# 07Sept04 Channel Adhoc Conference Call

- Test Point Verification
- SDD21
- SMA Launch if there is time

# Straw Poll Scope of Work

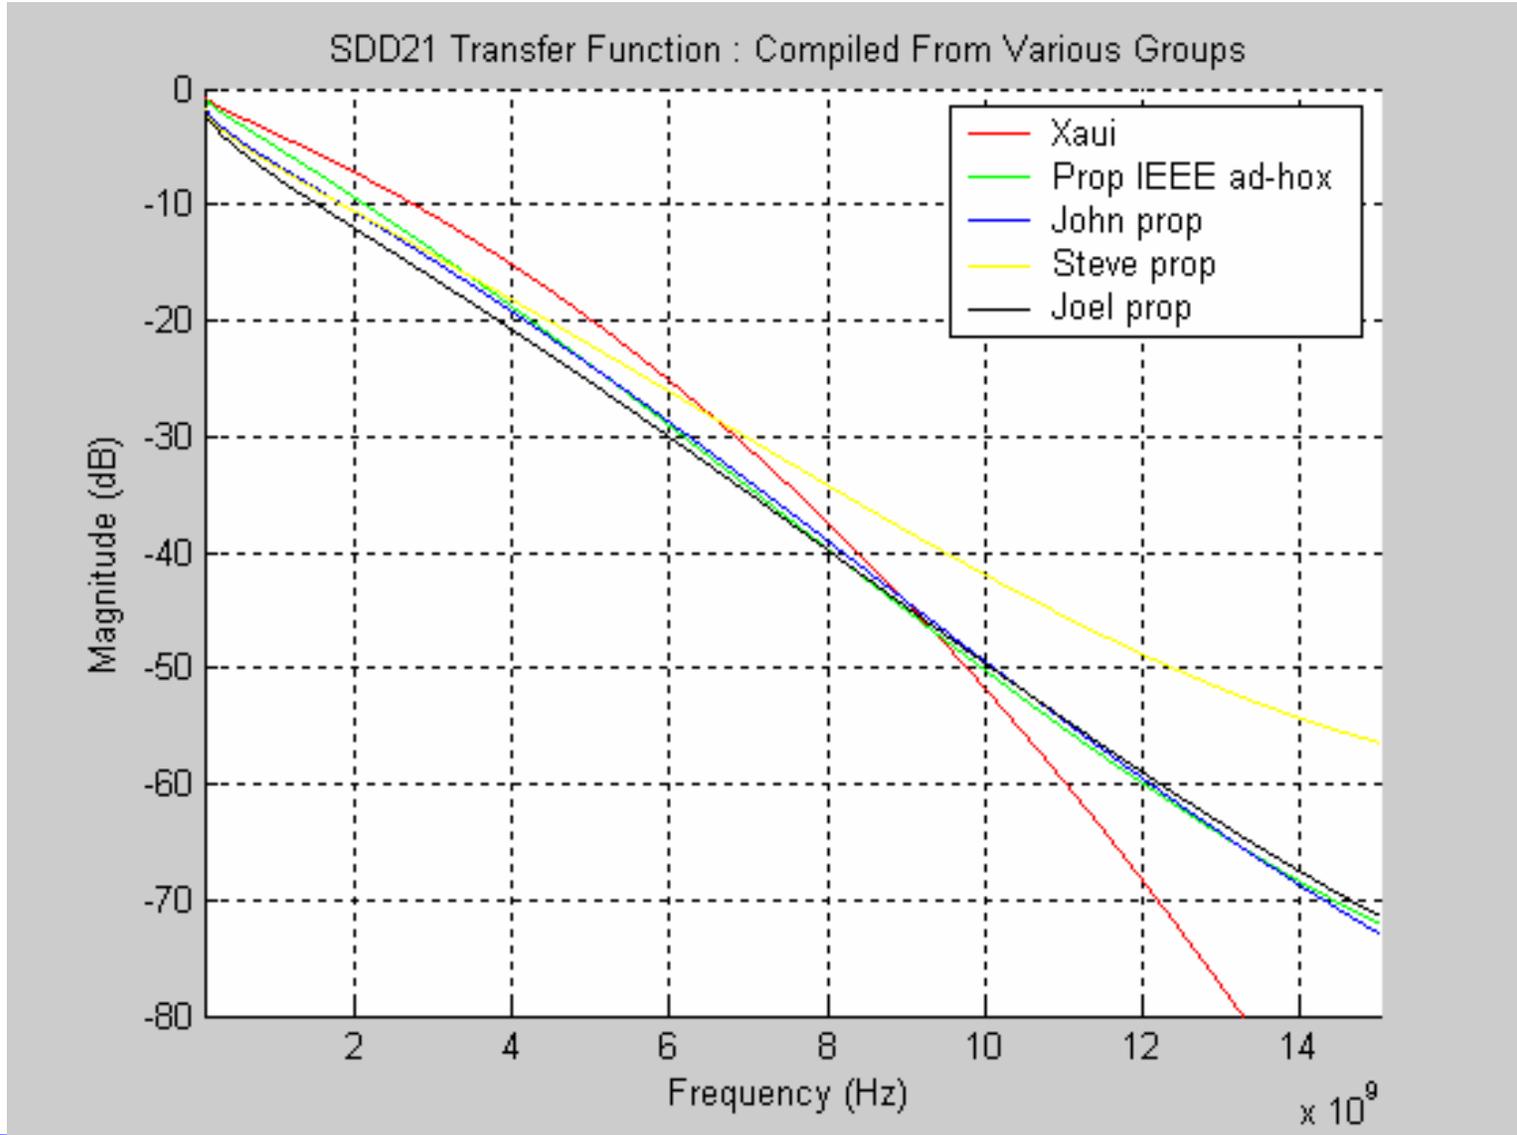
- ◆ SDD21 changes bounded to 50Mhz-6000Mhz max arc depth adjustment of 6db, the equation in goergen\_03-0704 staying intact with changes only to constants, the 6000Mhz-15000Mhz magnitude staying intact within 1dB.

- ◆ SDD11/SDD22 changes bounded to adjusting only the -12dB limit line portion to the better of 1) Data defined by the average limit of goergen\_02\_0704, mccallum\_01\_0704, peters\_01\_0704, seeman\_01\_0704, brink\_02\_0704; or 2) Correction to SMA launch pads, VIA stubs, and layer registration on goergen\_02\_0704 and mccallum\_01\_0704.

- ◆ NEXT/FEXT changes bounded to a max 6dB adjustment starting at the 50Mhz point, the equations in goergen\_03-0704 staying intact, based on correction to SMA launch pads, VIA stubs, and layer registration on goergen\_02\_0704 and mccallum\_01\_0704.

- ◆ Group Delay Variation changes bounded to a max change required to pass seeman\_01\_0504, +250ps/-450ps@10000Mhz, equations in goergen\_03-0704 to stay intact, and verified by correction to SMA launch pads, VIA stubs, and layer registration on goergen\_02\_0704 and mccallum\_01\_0704.
